Subject: Notice of Violation No. R9-2014-0154, Mission Gorge Apartments Construction Project, Order No. 2009-0009-DWQ, NPDES Permit No. CAS000002, Construction General Permit

NOTICE OF VIOLATION
No. R9-2014-0154

Mission Gorge Apartments Construction Project
PIN No. SM-826367:wchiu

FACILITY INSPECTION REPORT

Photo 14

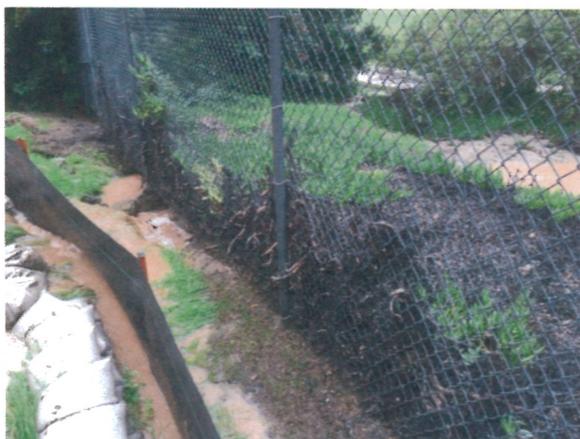
4. Lack of effective perimeter sediment controls observed which resulted in unauthorized sediment discharges from the site (See Photos 14 and 15). All construction sites are required to establish and maintain effective perimeter controls and stabilize all construction entrances and exits to sufficiently control erosion and sediment discharges from the site.

Photos 11 through 15 show pathway to unauthorized discharges of sediment and sediment-laden storm water runoff from the site to the San Diego River. Photo 11 shows area where runoff in Photos 5 through 8 collect. Photo 12 shows where runoff from Photo 11 flow down slope. Photo 13 shows where flow from Photo 12 emerges. Photo 14 shows where flow from Photo 13 and Photos 9 and 10 converge and discharge from location in perimeter controls (i.e. gravel bags) that appears to have been moved to allow flow off site. Photo 15 shows sediment-laden storm water runoff flowing off site to the San Diego River due to inadequate implementation of erosion controls, runoff controls within the site, and perimeter sediment controls.
